Source: Draft Impact Assessment Report, Strada Aggregates, Proposed Strada Pit/Quarry, by Earthfx, Aug 14, 2024
(See enclosed data Table)

Streamflow In and Out Impacts
Proposed Strada Quarry Operation Conditions
Horning's Mills Lake Between County Rd 124 (In) and Main Street (Out)

Fig H.6

Figure 3.3: Average Baseline Layer 1 Water Table and Streamflow

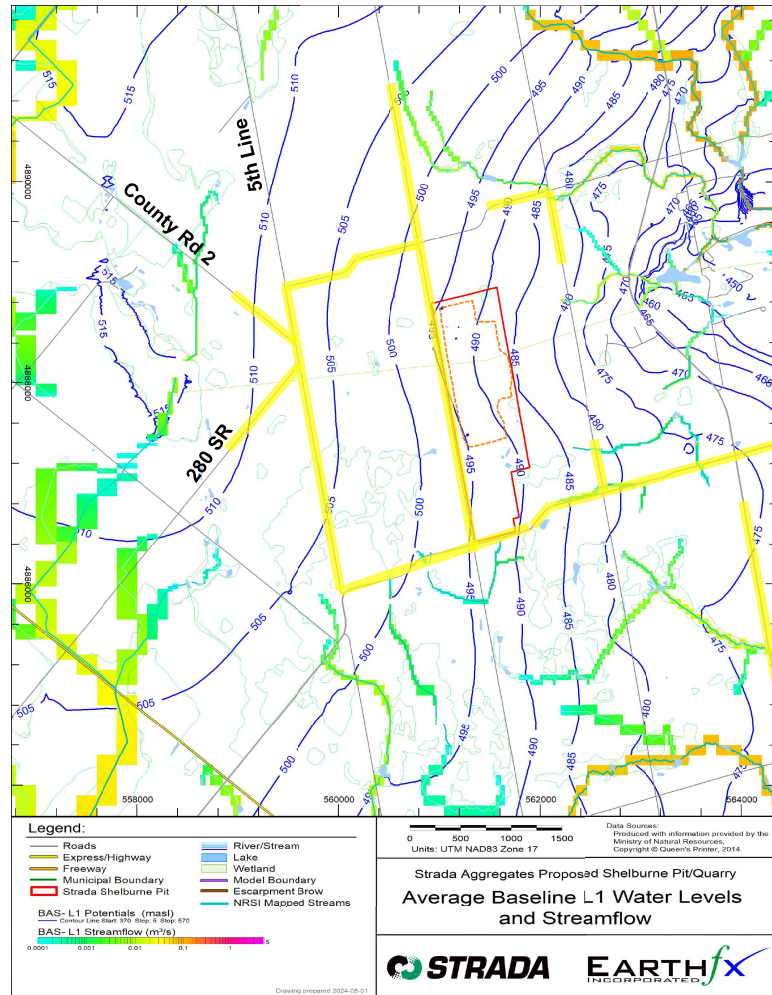
Model Baseline Water Table Condition for County Roads ()

Figure 4.35: Average Phase 4 Layer 1 Drawdown

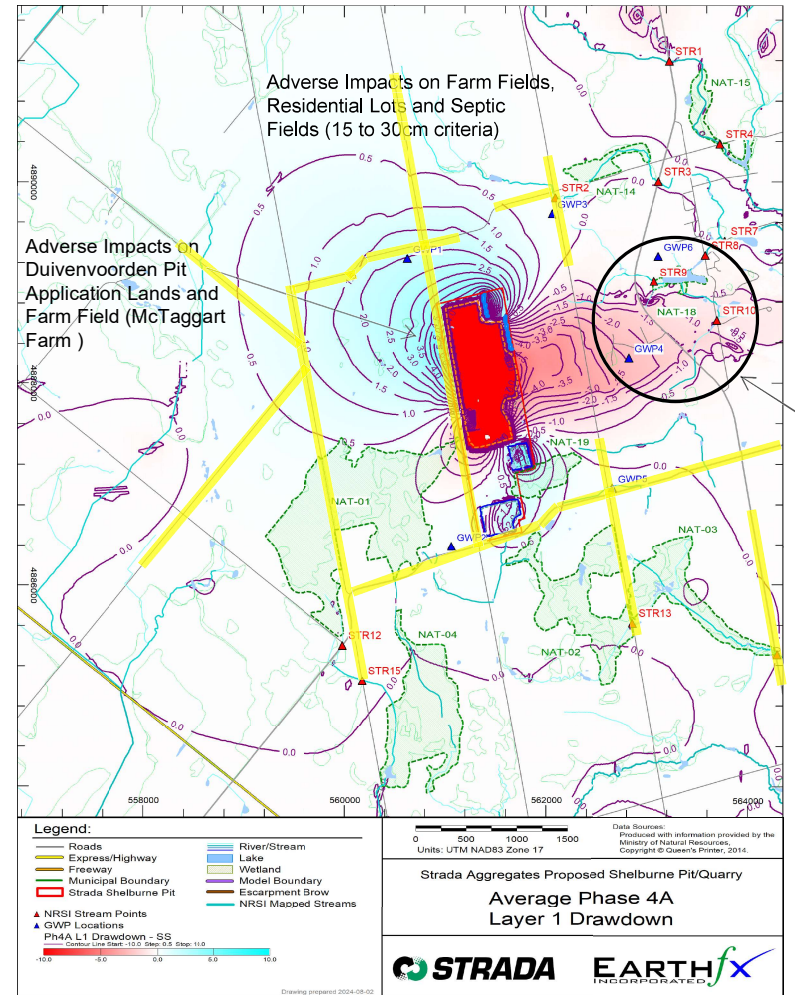
Model Adverse Water Table Rise (Phase 4 Layer 1) by County Roads ()

Adverse Impacts on Farm Fields, Residential Lots and Septic Fields (15 to 30cm criteria)

Adverse Impacts on Duivenvoorden Pit Application Lands and Farm Field (McTaggart Farm)

Adverse Reduction of Spring Flow, Pond Flowthrough and Streamflow in Pine River Headwaters.

Figure 3.5: Average Gasport Formation Water Levels

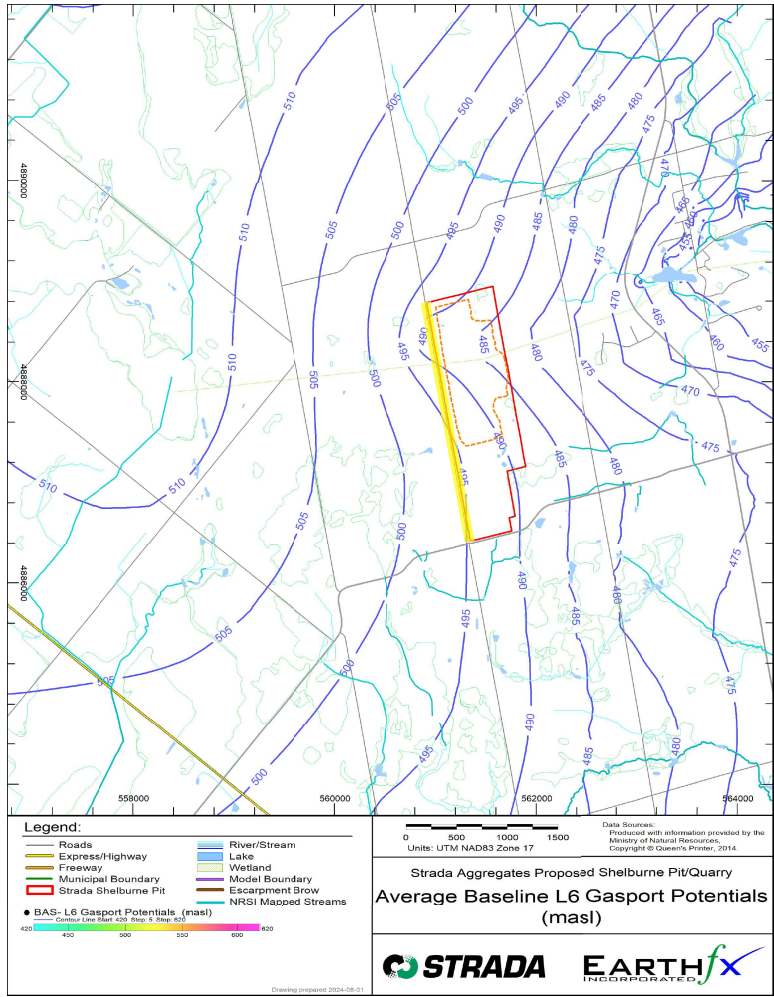
Model Water Level Potential (Baseline)

Figure 4.37: Average Phase 4 Layer 6 Gasport Drawdown

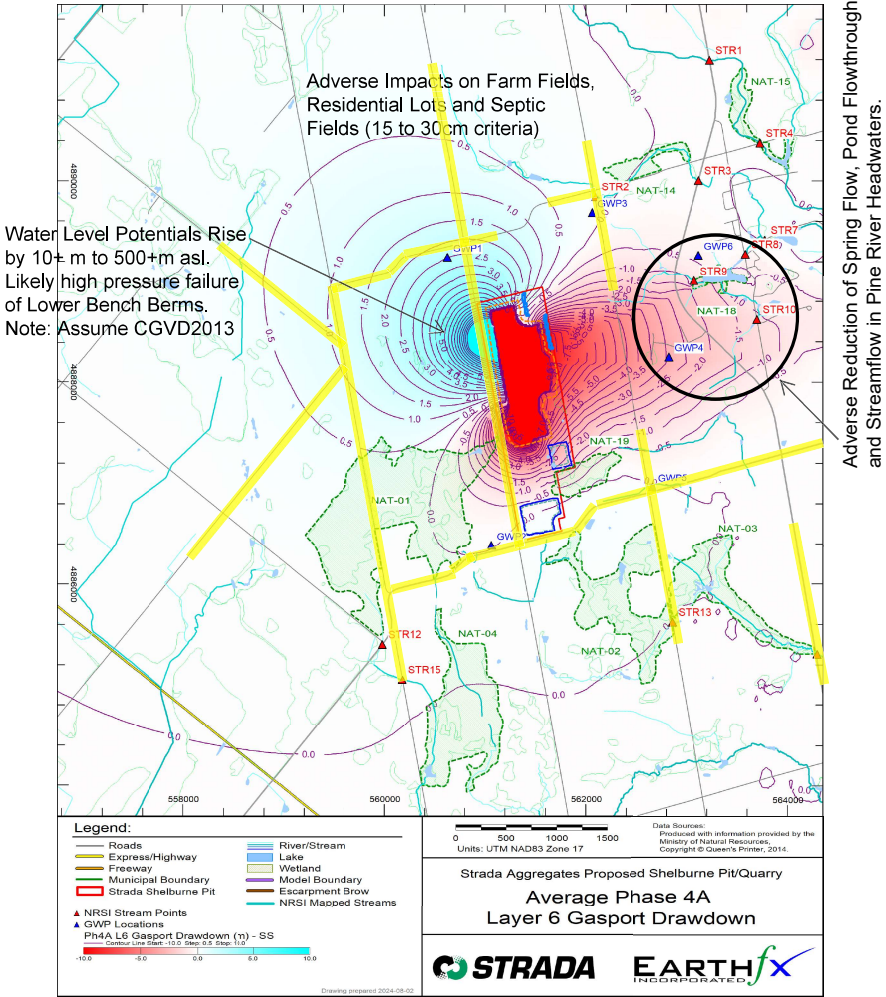
Increase in Water Level Potential - Phase 4 Layer 6 West of Prince Pit
